**Re: Site Review Permit & Lot Line Revision Applications
Proposed Mixed Use Development 53 Green Street, Portsmouth, NH**

The enclosed revised plans and supplemental materials have been provided to address comments received from the Technical Advisory Committee (TAC) in correspondence dated April 5, 2021 and at their meeting held on April 6, 2021.

PROPOSED MIXED USE DEVELOPMENT

City of Portsmouth TAC, April 06, 2021:			
	TAC Comment	Applicant Response	Sheet
TAC Comments from 4/5 Correspondence:			
1	Please show the proposed sewer easement to the City of Portsmouth on the lot line revision plan	Lot Line Revision plan will include the proposed sewer easement. The proposed sewer easement is shown on the Easement Plan and has been added to the Site Plan.	C-102.1, C-301
2	The Community Space easement should include the pedestrian passageway between the proposed new building and the AC Hotel. This is the only connection between Green Street and the Greenway along the North Mill Pond. Additionally, the easement should include the proposed access to the seat wall behind the building.	The Community Space easement has been adjusted on the Easement Plan.	C-301
3	The minimum width of the c

SITE PLAN

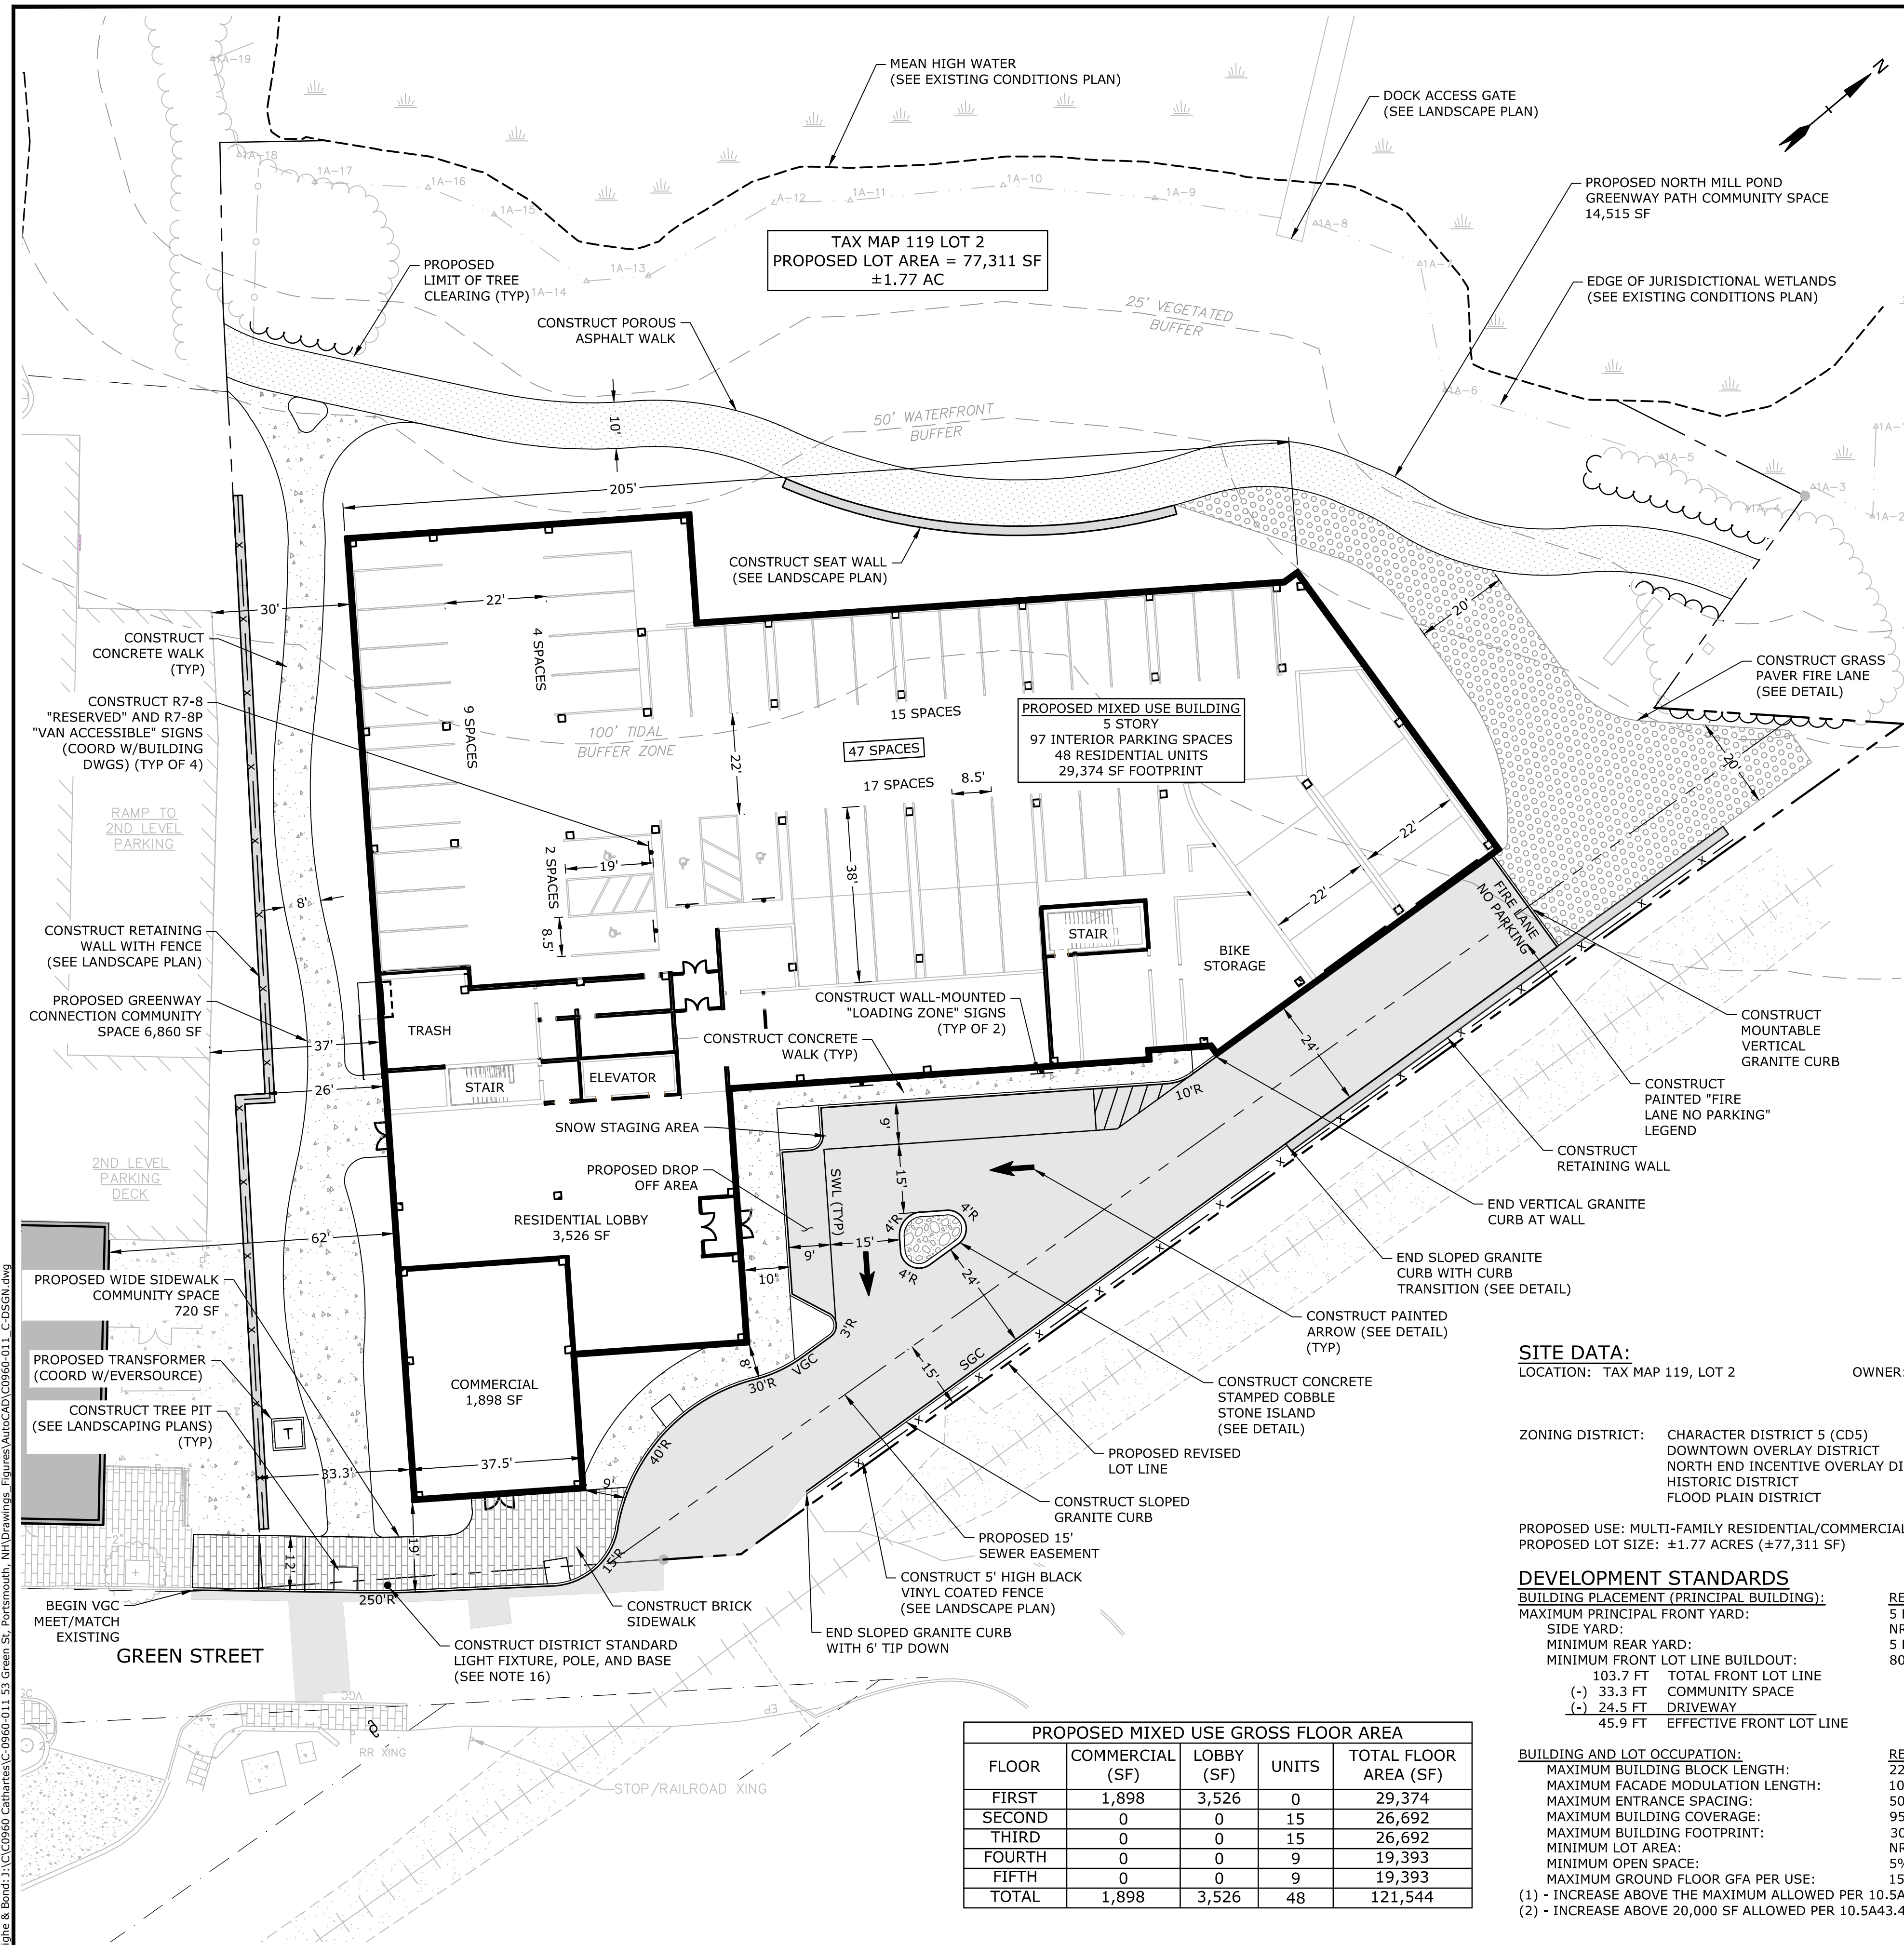
4	Min. Front Lot Line Buildout (FLLB) compliance needs to be verified.	Additional calculations have been added to the Site Data table to verify compliance.	C-102.1
5	Sheet C-102 Development standards footnote (2) needs to be reassigned to reflect the Overlay Incentive District requirements as Section 10.5A43.43 does not apply to this project.	The footnote has been revised.	C-102.1
6	Footnote #3 in the development standards chart should reference Section 10.5A46.10.	The footnote has been revised.	C-102.1
7	It appears that only 69 off-street parking spaces are required (versus 73) due to the DOD credit. Perhaps the three parallel spaces along the building frontage could be removed in order to support a larger raised and landscaped island to soften the impervious surface of the driveway, drop off area and sidewalks.	This area is required to remain as pavement for access purposes. The area will be reserved as short-term loading spaces.	C-102.1, Site Traffic Exhibit
